CIMARRON
CORPORATION
Annual Submittal
of 27(e) Changes

Re: Docket No. 70-925; License No. SNM-928
Annual Submittal of 27(e) Changes

LICENSE SNM-928, CONDITION #27(e) CHANGE EVALUATION FORM

Figure 3-1

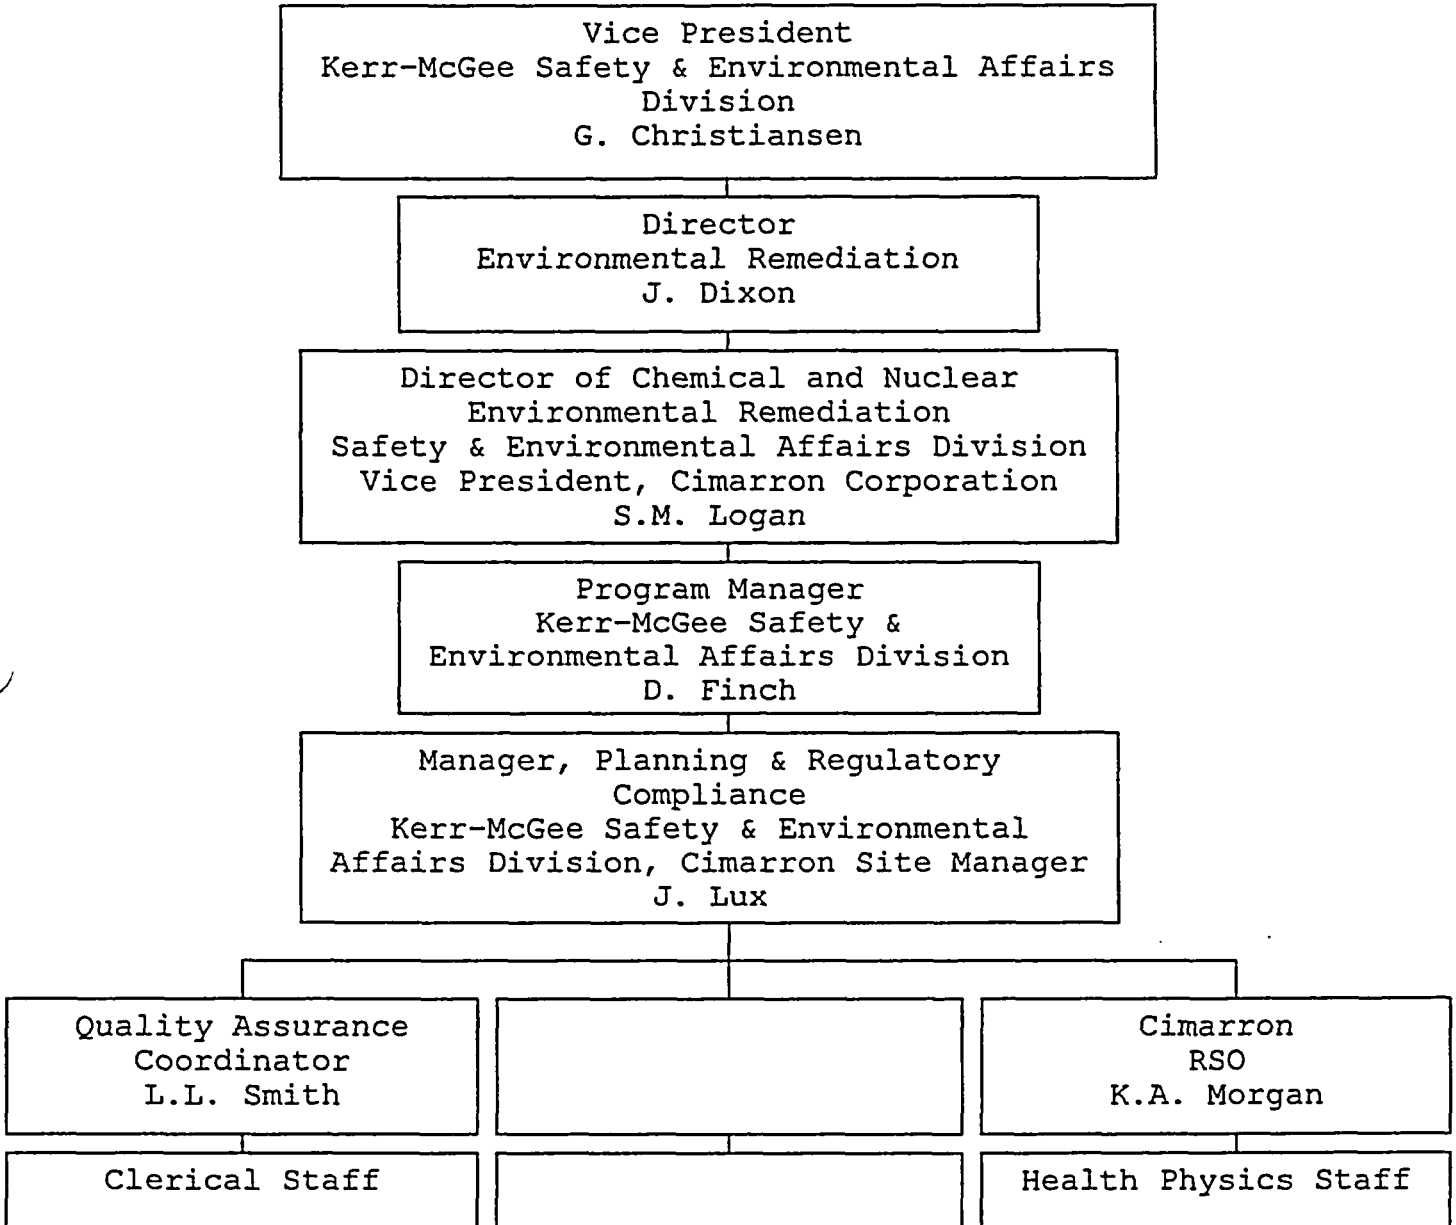
Section 3, Figure 3-1 – Removal of Decommissioning Supervisor from Organizational Structure Chart.

- Section 3, Figure 3-2 were revised to reflect changes in the organizational chart due to the removal of the position of decommissioning supervisor.

Figure 3-1

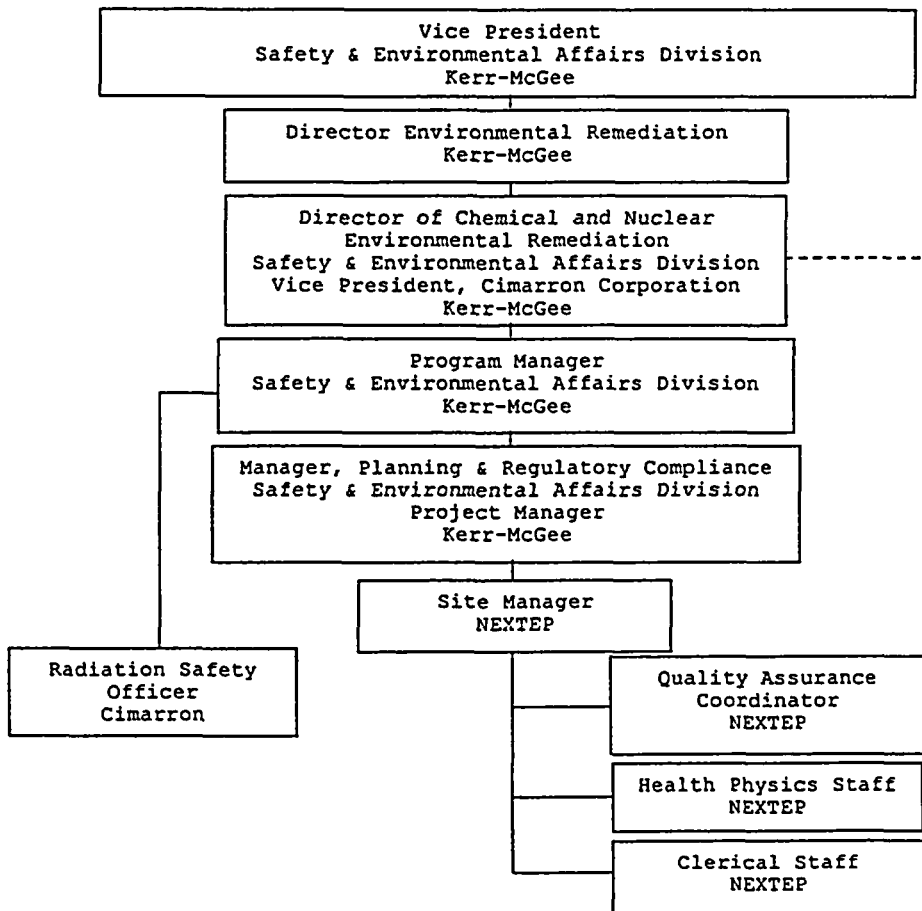
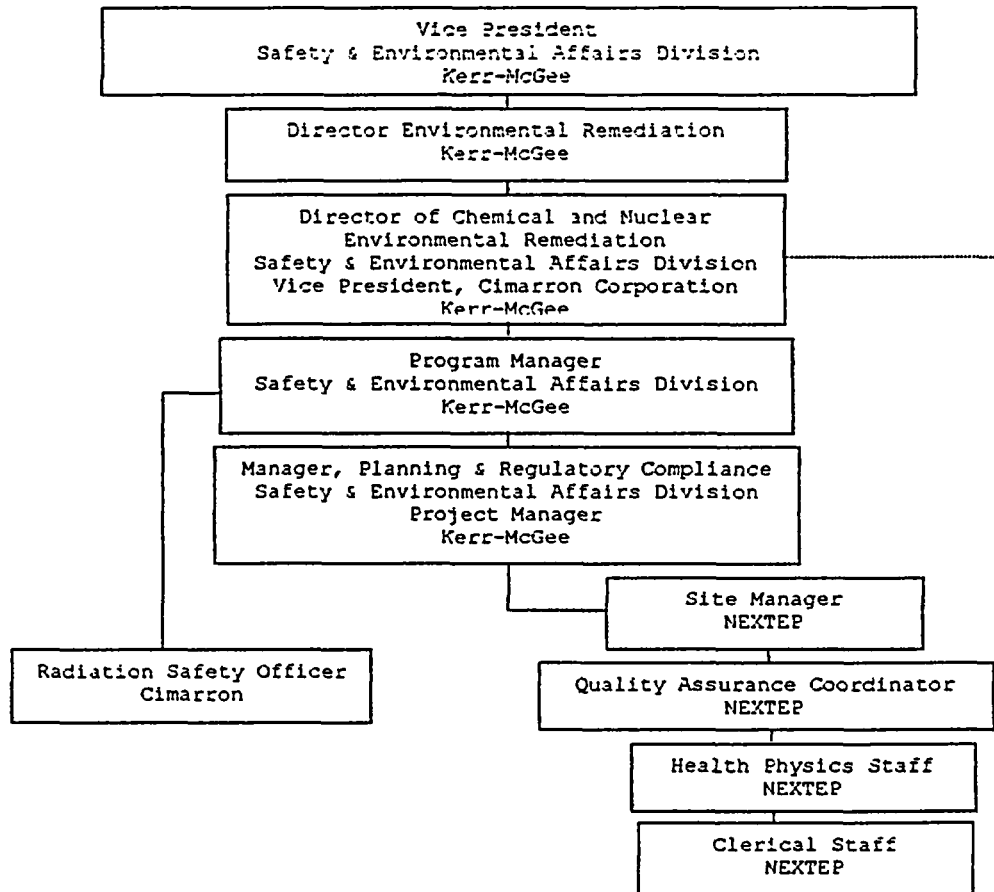
Revision to Organizational Chart – Responsibilities and Titles – Sections 2, 3, 4, 9, 12, 14

- Revisions to the Cimarron Organizational Chart reflecting titles and responsibilities.

Figure 3-1

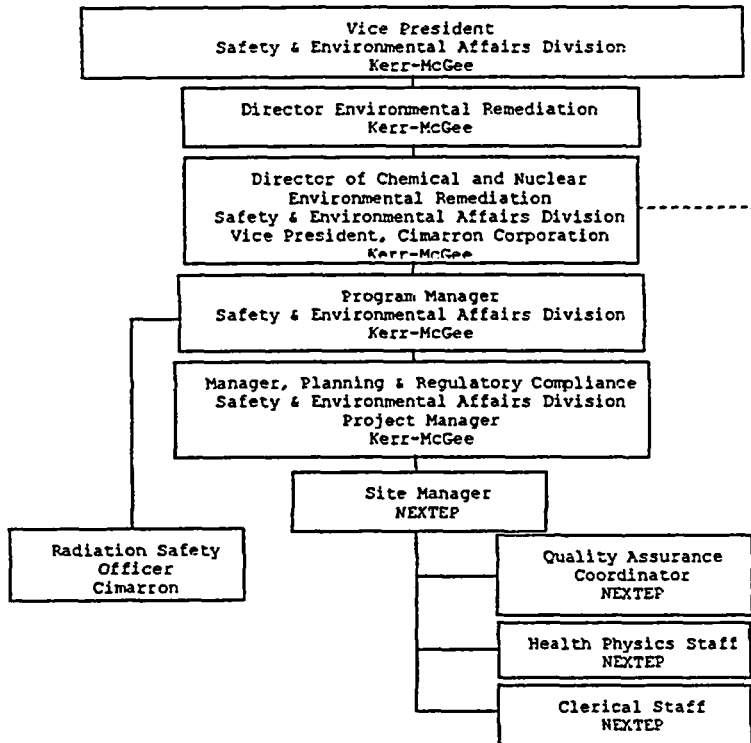
- Revisions to the Cimarron Organizational Chart.
- Revisions to facility titles and responsibilities.
- Revisions to Sections 2, 3, 4, 5, 9, 12, and 14 reflecting the above changes.
- Table of Contents page.
- Signature Page.

The current organizational structure for Cimarron Corporation is presented in Figure 3-1. Radiation Protection staffing levels shall be maintained in consistency with current and planned activities. Duties and responsibilities that are required for health physics procedure shall be clearly defined.
